SERVICE LETTER 253

Horizontal Stabilizer Spar Cracking At Finlets

Aircraft Makes/Model(s):	Float Model(s):	Compliance: Mandatory	By: MAS
Air Tractor AT-802 & AT-802A	10000A	Part Number: 1012347	Approved: DRH
		Date: 7/3/2024	Revision: D

Figure 6

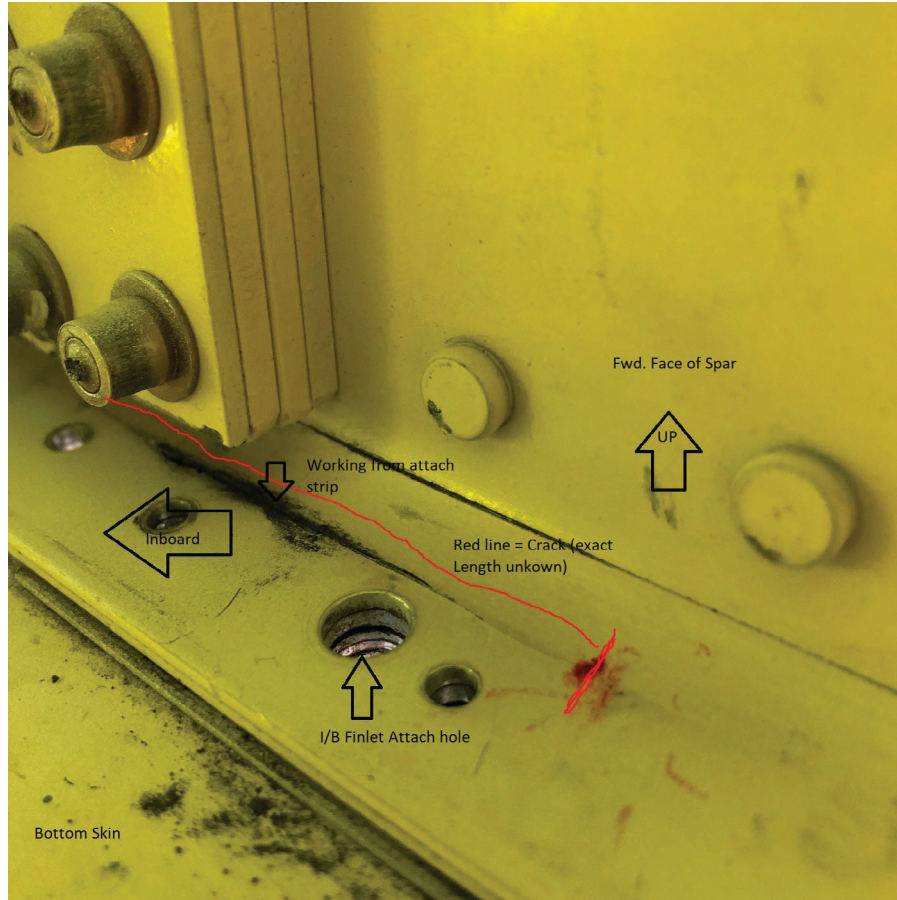
5. Clean the area that is to be inspected.
6. Visually inspect for cracks on the forward and aft horizontal stabilizer spars, including both upper and lower flanges and the web area between. Two primary varieties of cracks have been observed. These are described below to aid inspection, but the entire area is to be thoroughly examined:
 - a. A crack originating in the spar web above the forward, outboard mount bolt of the lower finlet. See Figures 4 and 5.
 - b. A crack near the forward, inboard mount bolt, typically within the radius of the spar, and perhaps centered at the corner of the strut brace shim plates. See Figure 6.

7. If no cracks are present continue to the next step, otherwise:

Any cracks discovered in this area of the horizontal stabilizer spar necessitate replacement of spar; the procedure for replacing the spar is beyond the scope of this service letter. Forward spar assemblies may be ordered directly through Wipaire. See the parts list in the WORK INSTRUCTIONS – INSTALL BATHTUB FITTINGS section.

Figure 9
Alternate Skin Patch

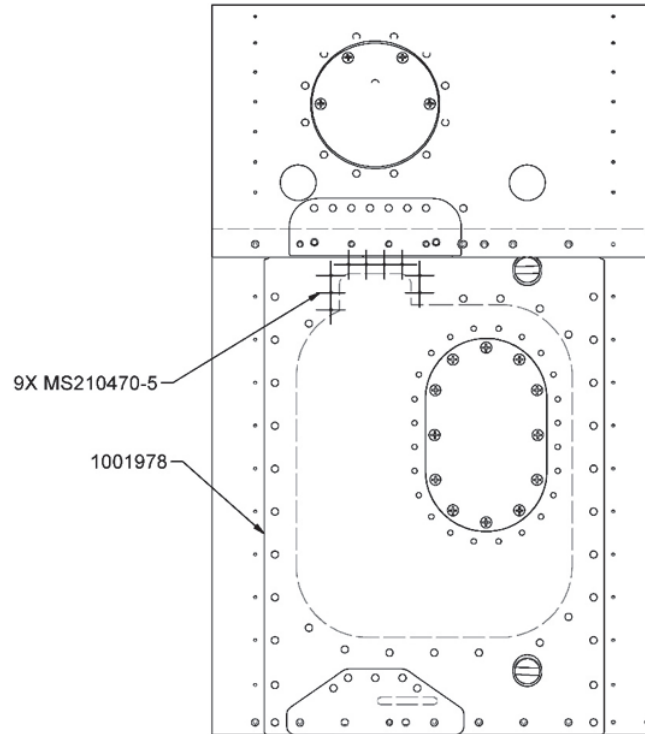
Note: Service Letter kit utilizes an alternate skin patch to accommodate prior modification of stabilizer skin. (1001978 in place of 1001971)
